H. B. ROBINSON STEAM ELECTRIC PLANT, UNIT NO. 2  
DOCKET NO. 50-261/LICENSE NO. DPR-23

TRANSMITTAL OF EMERGENCY PROCEDURE REVISIONS

**EPEOF-03**

REVISION 6

ATTACHMENT 8.3.5.3  
Page 1 of 1  
EOF NRC SUPPORT ROOM RECOMMENDED LAYOUT

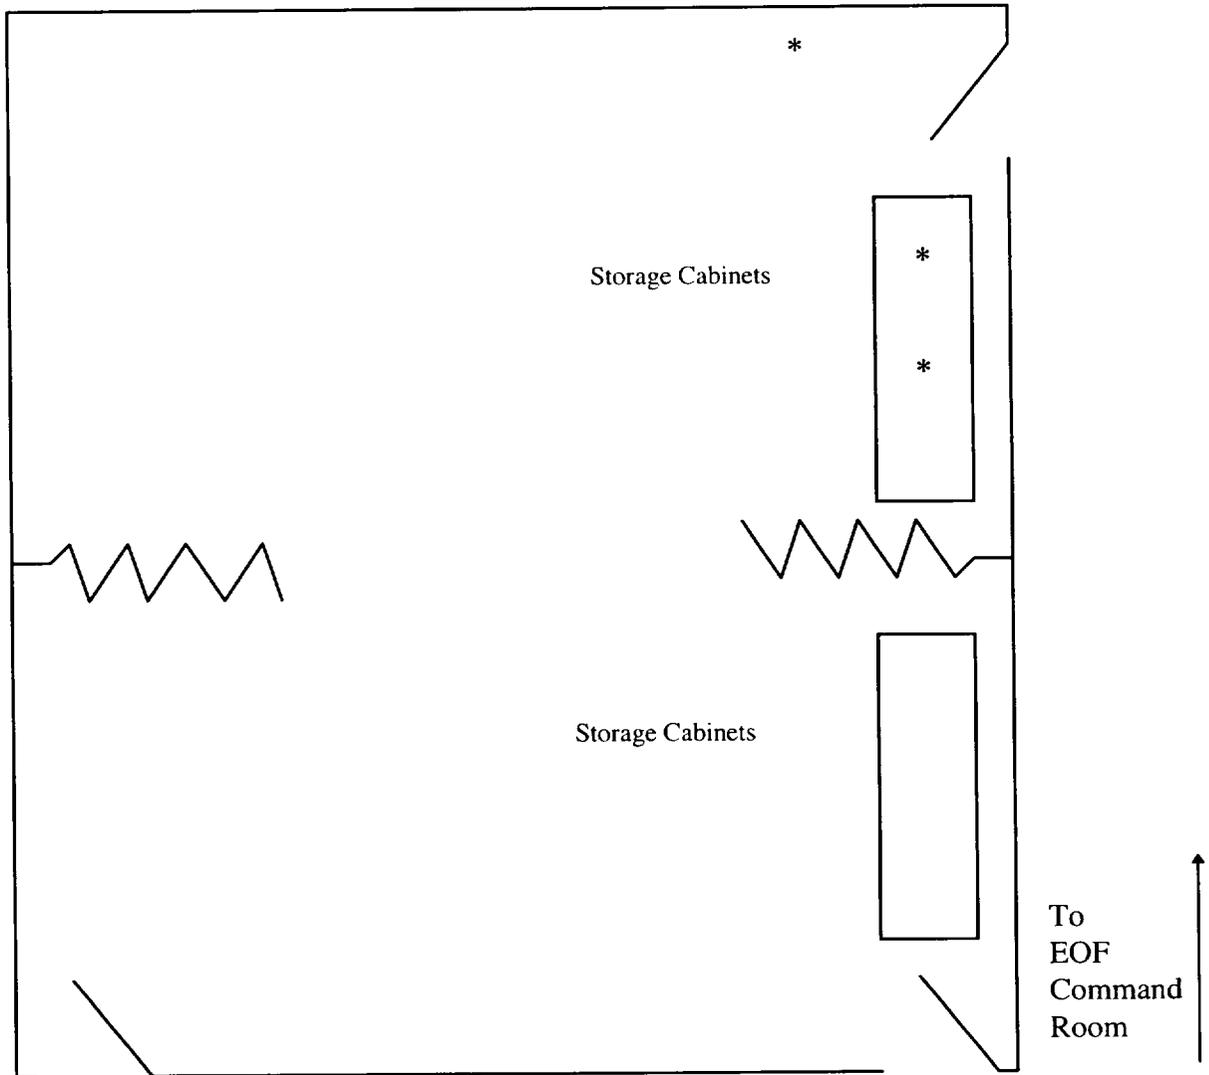
| <b>STEP</b>       | <b>REVISION COMMENTS</b>   |
|-------------------|--|
| Attach 8.3.5.3    | Revised drawing to reflect conversion from FTS 2000 terminology to Emergency Telecommunication System. |

ATTACHMENT 8.3.5.7  
Page 1 of 1  
**ACCIDENT ASSESSMENT ROOM RECOMMENDED LAYOUT**

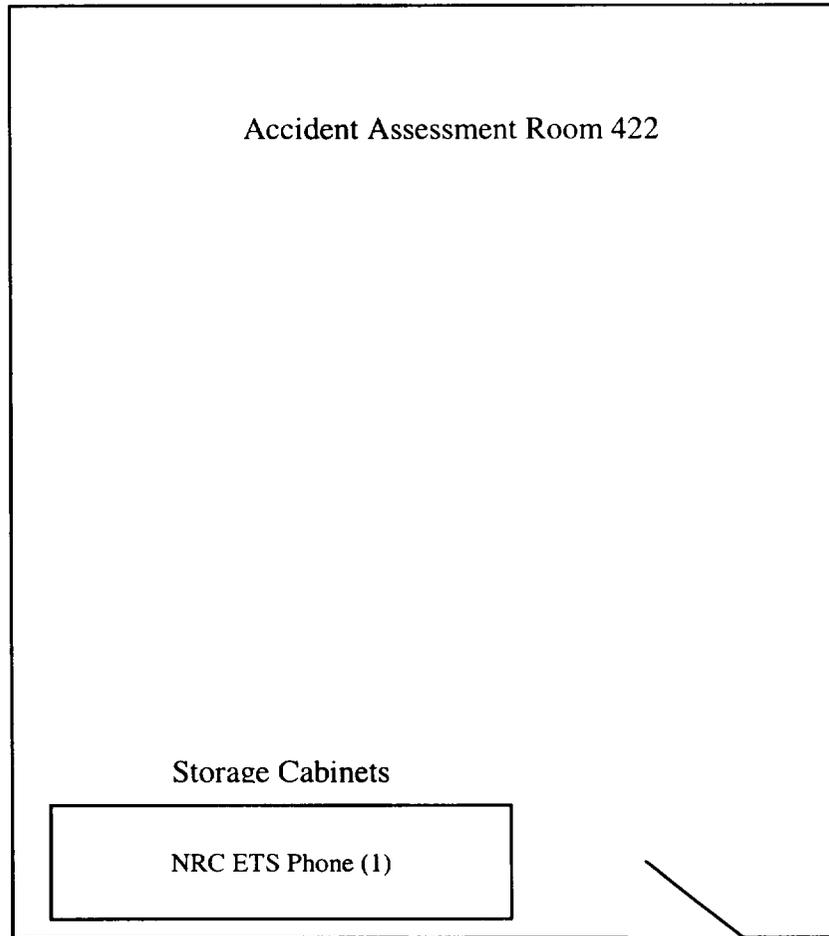
| <b>STEP</b>       | <b>REVISION COMMENTS</b>   |
|-------------------|--|
| Attach 8.3.5.7    | Revised drawing to reflect conversion from FTS 2000 terminology to Emergency Telecommunication System. |

ATTACHMENT 8.3.5.8  
Page 1 of 1  
**SUPPORT SERVICES ROOM RECOMMENDED LAYOUT**

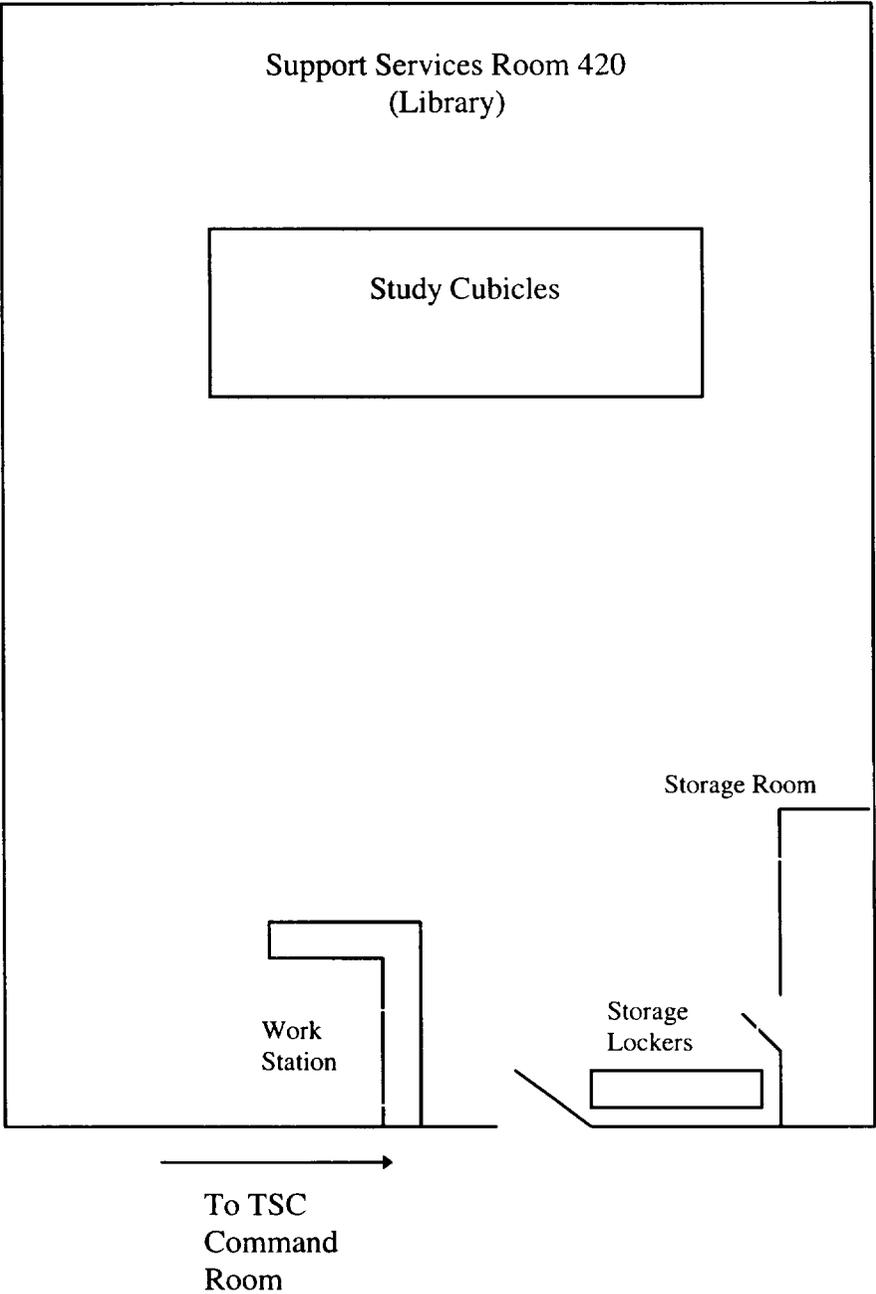
| <b>STEP</b>       | <b>REVISION COMMENTS</b>   |
|-------------------|--|
| Attach 8.3.5.8    | Revised drawing to reflect conversion from FTS 2000 terminology to Emergency Telecommunication System. |

ATTACHMENT 8.3.5.10  
Page 1 of 1  
**TSC NRC SUPPORT ROOM  
RECOMMENDED LAYOUT**

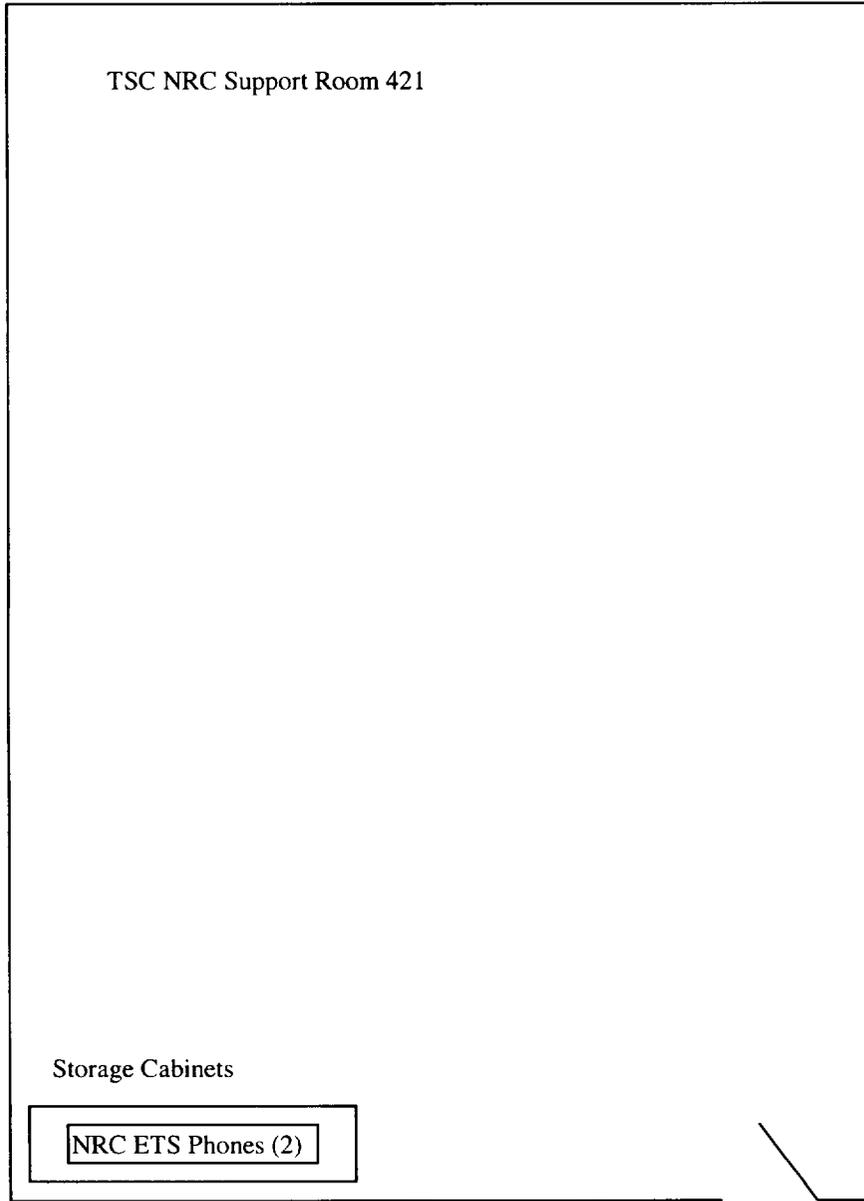
| <b>STEP</b>       | <b>REVISION COMMENTS</b>   |
|-------------------|--|
| Attach 8.3.5.10   | Revised drawing to reflect conversion from FTS 2000 terminology to Emergency Telecommunication System. |
